SUBJECT: Michigan Department of Environment, Great Lakes, and Energy (EGLE) comments on the Area 2 Pre-Design Investigation (PDI) Work Plan: Phase 2 (Phase 2 FSP), submitted March 15, 2023, Operable Unit 5 (OU5), Allied Paper Inc./Portage Creek/Kalamazoo River Superfund Site (Site).

Allied Paper Inc./Portage Creek/Kalamazoo River Superfund Site
Pre-Design Investigation Work Plan: Phase 2, Area 2, Operable Unit 5, Draft dated March 2023

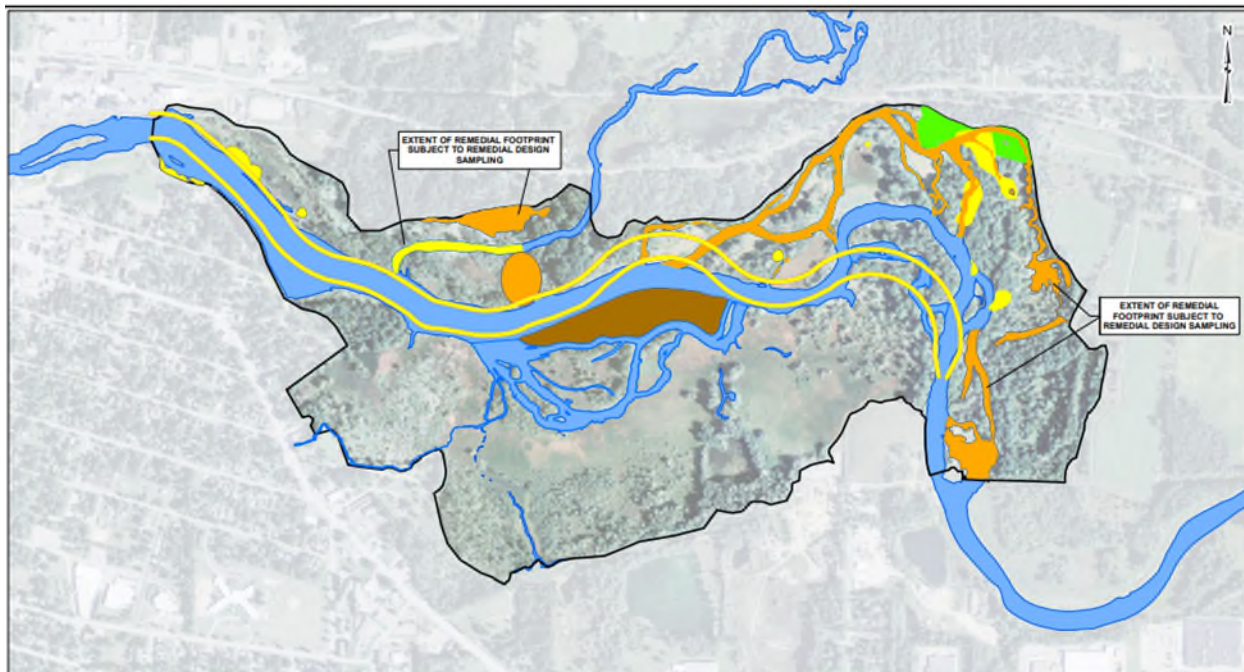
General Comment #2: It is not clear if the single DQO in the Phase 2 FSP will generate enough information to develop a RD and implement the remedy.

The Phase 2 FSP is primarily focused on delineating the total PCB footprints above thresholds of interest, with the exception of a few locations where geotechnical sampling is proposed. According

to text in the Phase 2 FSP, the DQO for defining the PCB remedial footprint was developed to mirror requirements of the selected remedy, which includes excavation of floodplain soil with PCB concentrations greater than 50 mg/kg and 20 mg/kg, addressing privately owned property with PCB concentrations greater than 2.5 mg/kg, and excavating sediment from the Gun River to achieve a PCB SWAC of 0.33 mg/kg.

However, the selected remedy includes significantly more elements than excavation of contaminated materials, including dam removal, bank excavation for PCBs to a RAL of 5 mg/kg, channel realignment with delineation/disposal of PCBs above the PRG within the realignment footprint, the beneficial reuse of “clean” material excavated during construction of the realigned channel for use as fill, etc.

The number of cores and the core density proposed for the PDI is fairly low, especially when compared to estimates in the Area 2 Feasibility Study (FS). Cost estimates for the selected remedy (Alternative A5 with Channel Realignment Option 3) in the FS assumed that 500 cores would be collected during the PDI to support the RD, which would be similar to the combined efforts of the pre-SRI (approximately 369 cores) and SRI (approximately 338 cores) sampling. However, the total number of core locations proposed for the Area 2 PDI may be less than half of the projection in the FS, and the PDI will be smaller in scope than the pre-SRI and SRI sampling events.

If there are plans to conduct additional sampling to support the RD after Phase 2 is completed, indicate what additional information needs to be collected and when that work will be done. An incomplete PDI may hamper development of a preliminary (30 Percent) RD.

If there are no plans to conduct additional sampling after Phase 2 is completed, revise the Phase 2 FSP so that it includes DQOs to address the remaining data gaps. A technical work group meeting to discuss the remaining data gaps and develop DQOs may be necessary/beneficial to ensure that the pre-design investigation is sufficient to support the RD. Revise the document accordingly.

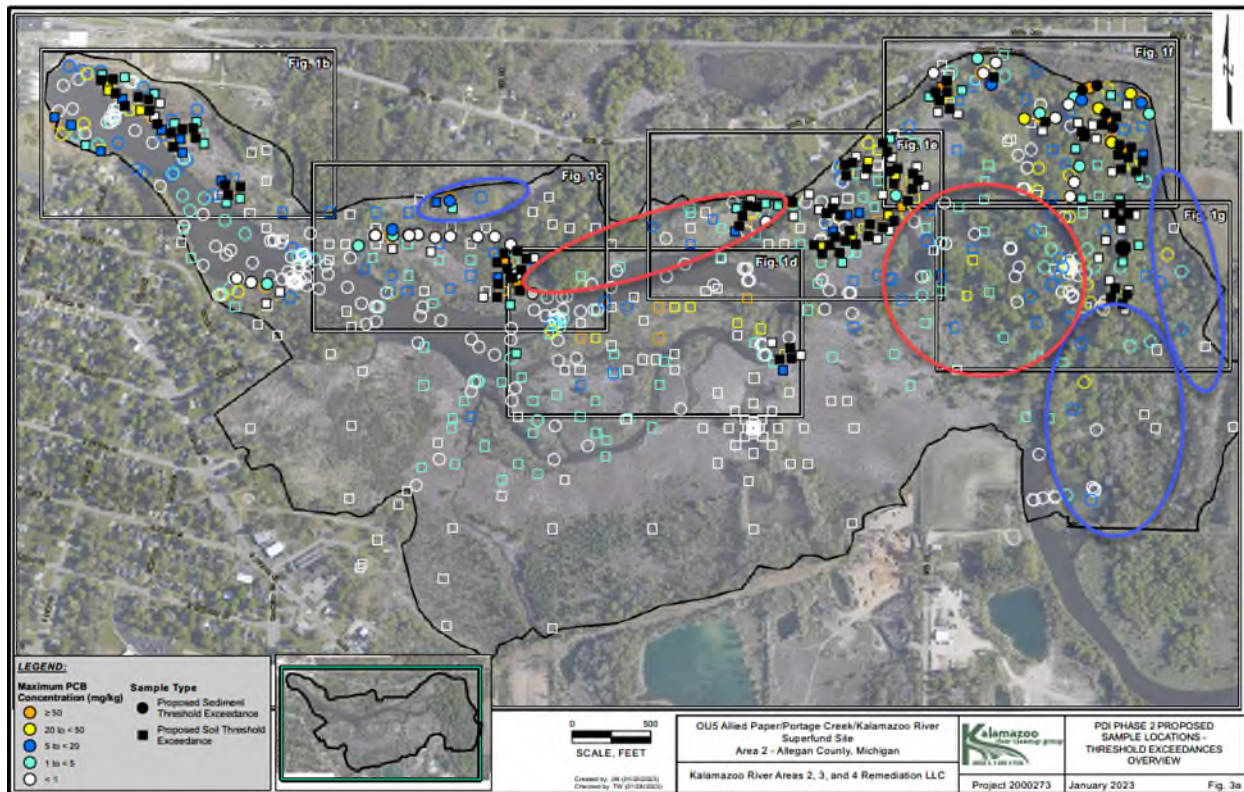
The spatial extent of the PDI also appears to be incomplete for what would be needed to support the development of a RD and implement the remedy. Locations identified in the Record Of Decision (ROD) for sampling during the RD such as the area downstream of the former Plainwell dam, and Pond G appear to have not been included as part of the PDI (circled in purple). The PDI also does not appear to include any samples in locations where the new river channel will be constructed, including the floodplain to the north of Knife Blade Island, and the southern floodplain located just downstream of the former Plainwell dam (circled in red). There is also no sediment sampling proposed for the main river channel, including those portions that overlap with the future channel alignment.
